Irish Cruising Club

South and West Coasts of Ireland Sailing Directions

14th edition published February 2016
Amendments to 8 October 2017

Consolidated Amendments to 27 March 2017

Dunmore East yacht pontoon (Peter Mason)

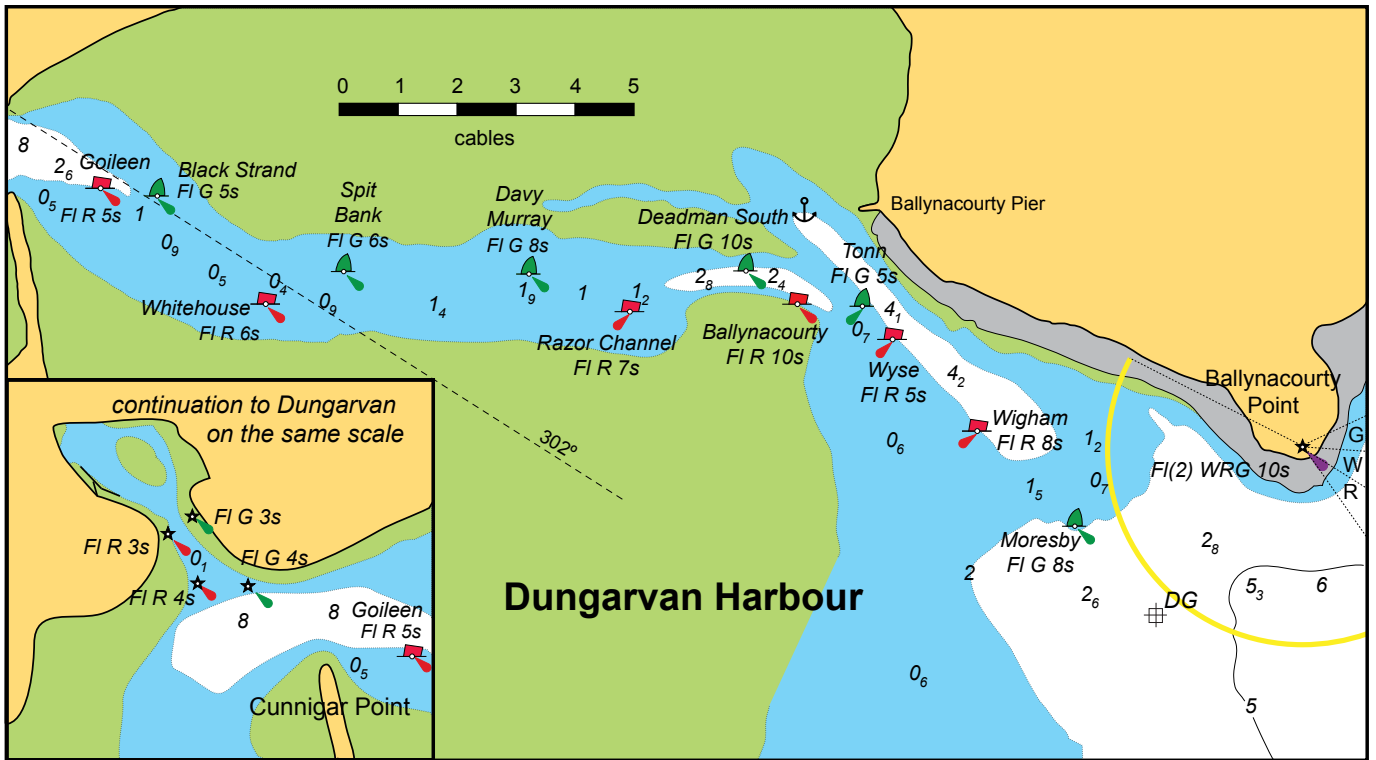
Page 38R, **Dunmore East** harbour: a 60m pontoon for the use of visiting yachts has been installed inside the NE breakwater extension. The pontoon has water and shore power.
